# 802.3cu D1.1 PMD Spec Proposed TX Changes

P802.3cu 100 Gb/s and 400 Gb/s over SMF at  
100 Gb/s per Wavelength Task Force Ad Hoc

8 January 2020

8% overshoot BtB 3.3V 25°C

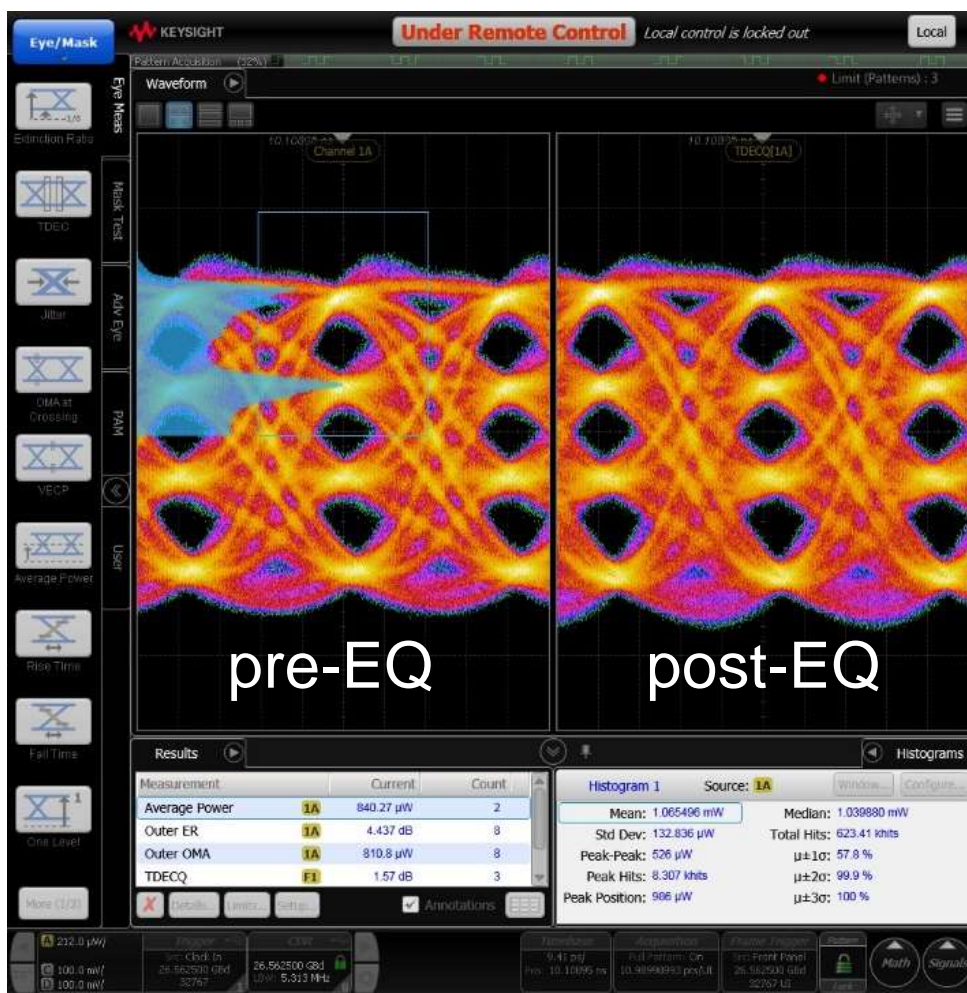
# 26.6 GBaud PAM4 1305nm $\lambda$ 13.3GHz RX BW

13.5% overshoot BtB 3.3V 25°C

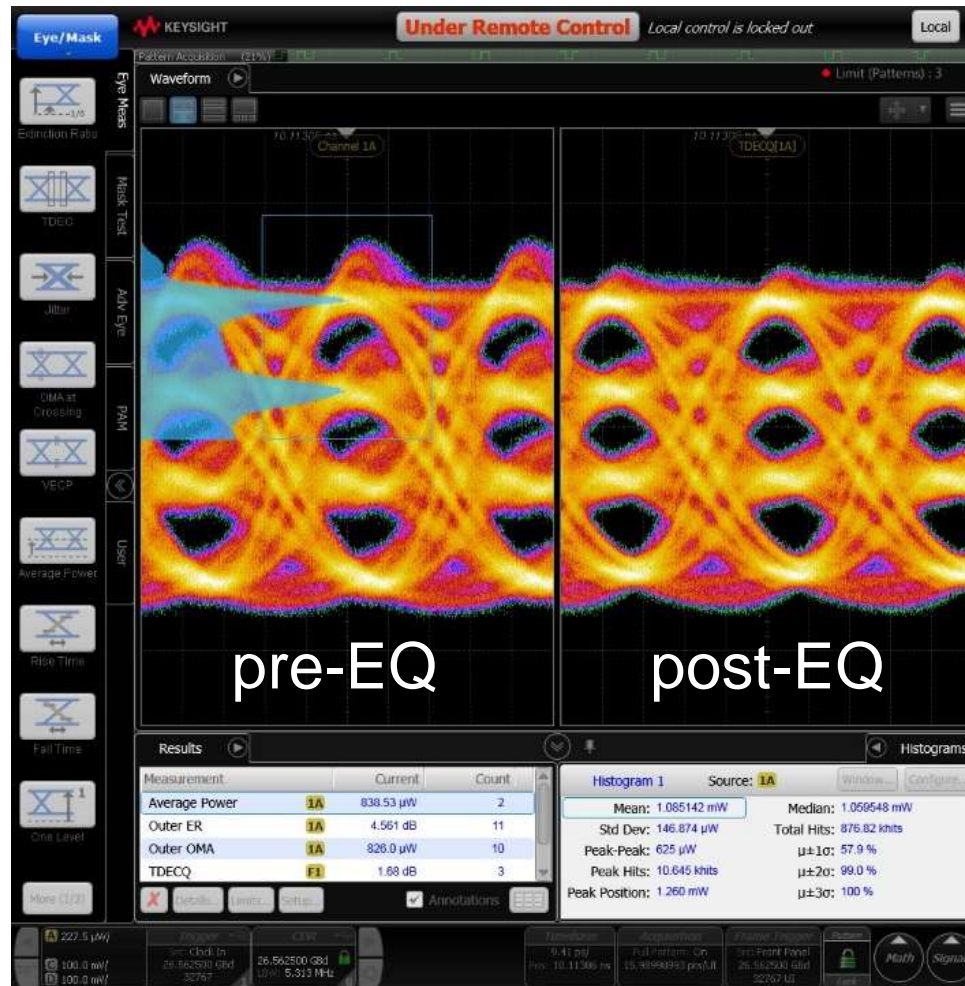
# 26.6 GBaud PAM4 1305nm $\lambda$ 13.3GHz RX BW

19% overshoot BtB 3.3V 25°C

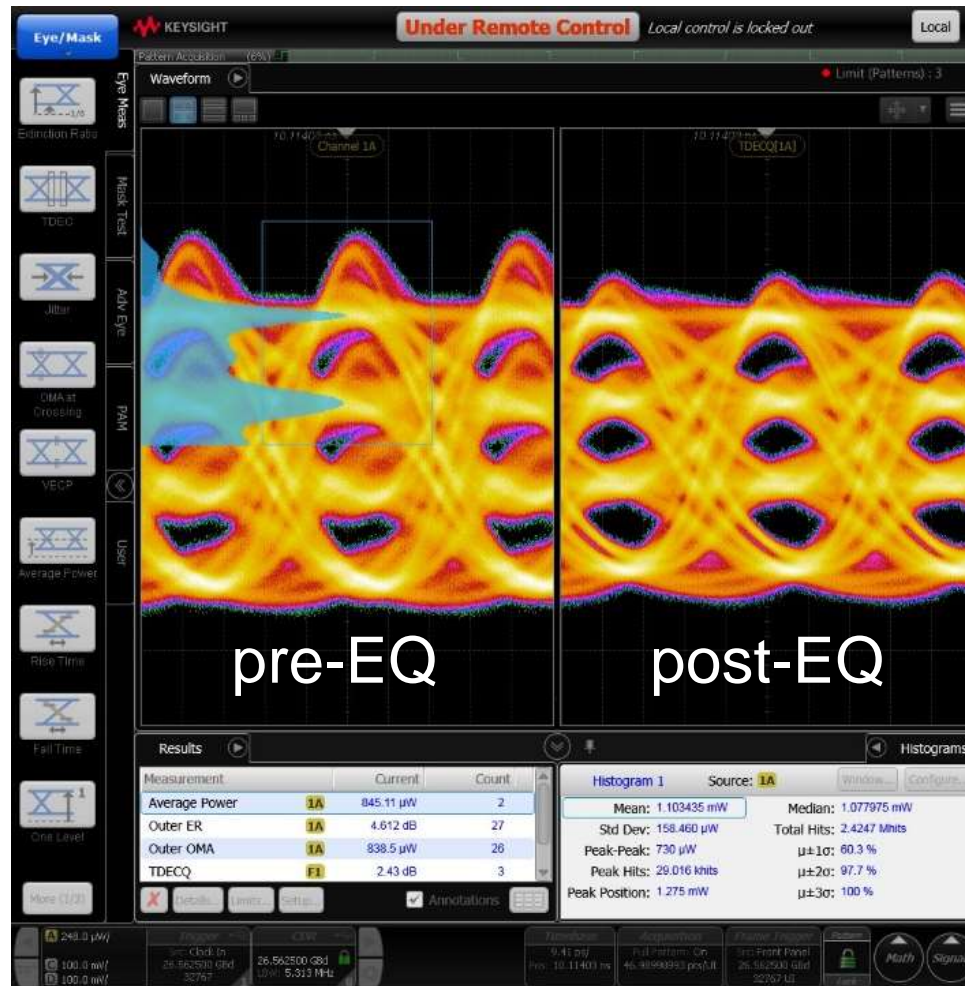
# 26.6 GBaud PAM4 1305nm $\lambda$ 13.3GHz RX BW

## 26.6 GBaud PAM4 1305nm $\lambda$ Link Operation

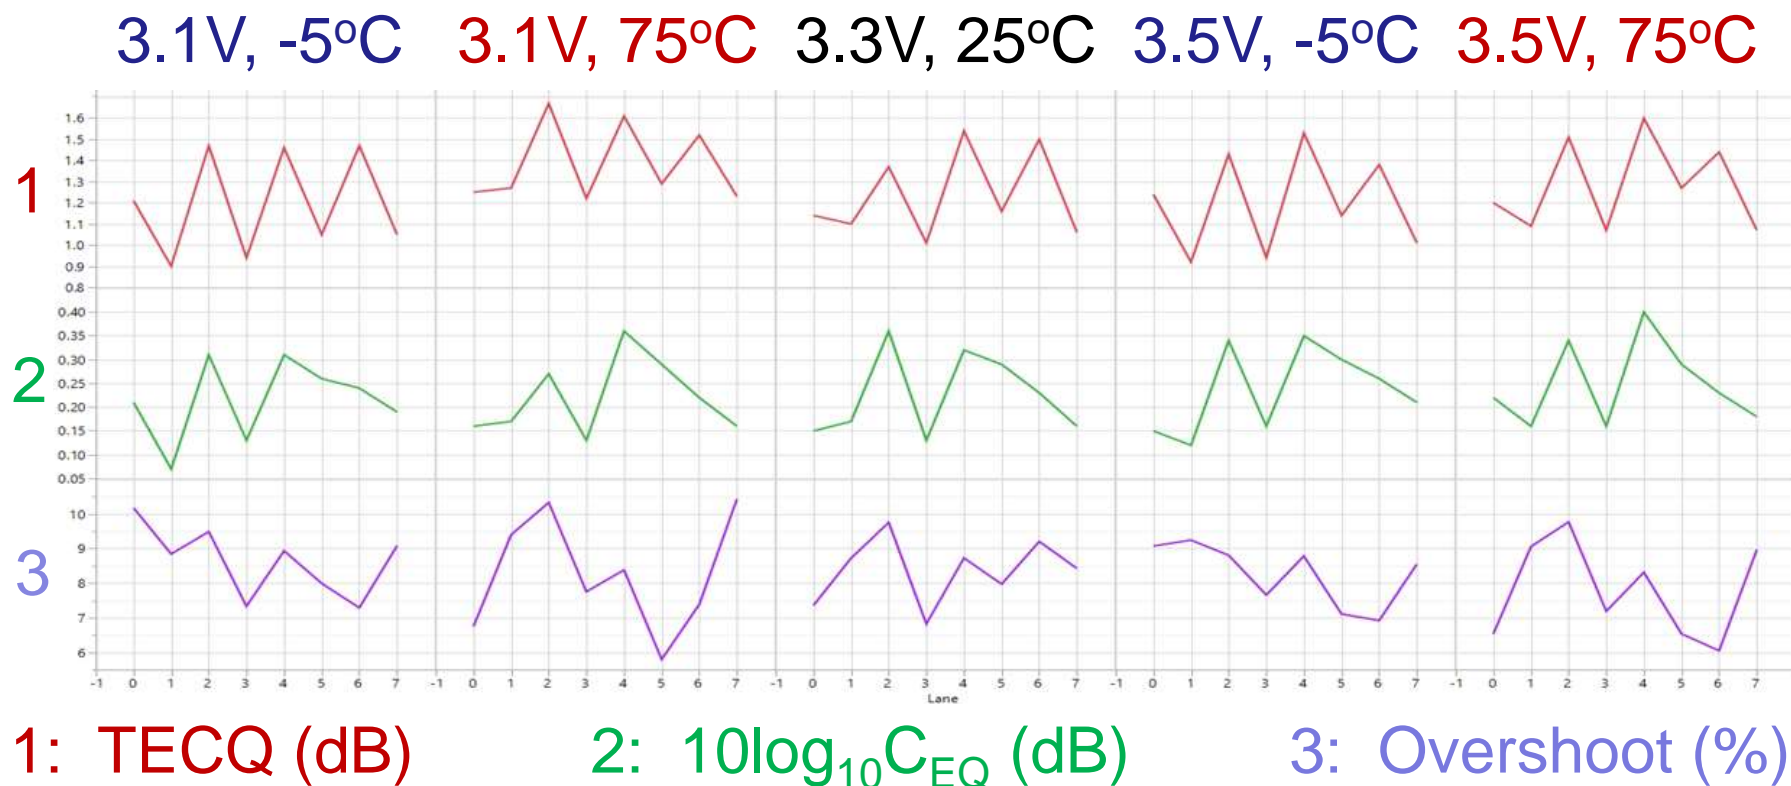
Overshoot (13.3GHz RX BW) %	TECQ (BtB) dB	TECQ - 10log10 (Ceq) dB	TDECQ (disp. = -30ps/nm) dB	TDECQ - 10log10 (Ceq) dB	Operation (BtB)
8	1.5	1.3	1.2	1.4	normal
13.5	1.45	1.7	1.5	2.1	LOL
19	1.3	2	2.2	3.2	LOL

Production units are set-up for  $\leq 12\%$  overshoot over 5 corners
